Detailed Assessment Report

Item 8.5.1 Development Application for a Material Change of Use (Mixed Use
Development) - Brisbane Rd & 7, 9, 13 & 15 First Ave, 11 Smith St,
Mooloolaba

Attachment 3 Detailed Assessment Report

APPLICATION NO: MCU17/2169

Public domain plan

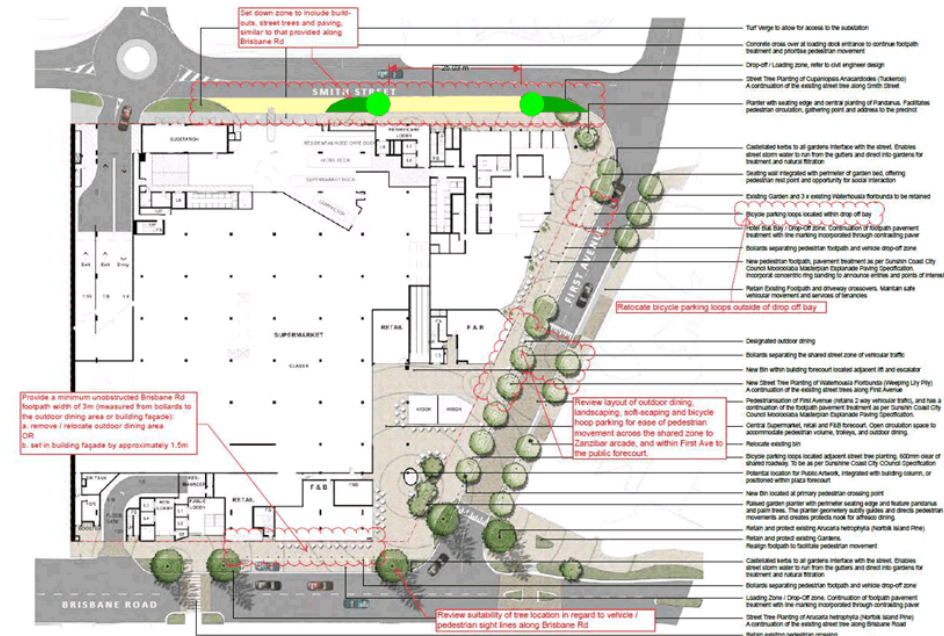
The proposed development includes significant sub-tropical landscape contributions with the public realm street frontages including First Ave shared zone, ground level and podium, and largely complies with the code. Minor amendments are required to the Landscape Concept Ground Floor Plan to achieve compliance with the code:

- Review suitability of street tree position at the corner of Brisbane Rd and First Ave
- Review layout of outdoor dining, landscaping, soft-scaping and bicycle hoop parking for ease of pedestrian movement across the shared zone to Zanzibar arcade, and within First Ave to the public forecourt.
- Relocate First Ave bicycle parking loops outside of drop off bay.
- Revise design of Smith Loading dock driveway and set down zone to reflect a similar standard of works provided within Brisbane Rd.
- Provide a minimum unobstructed Brisbane Rd footpath width of 2.5m (edge of building facade or outdoor dining area to bollards or edge of kerb):
 - a. remove / relocate outdoor dining area
 - OR
 - b. set in building façade

Amended plans will be required to be submitted to council for approval prior to operational works approval being granted.
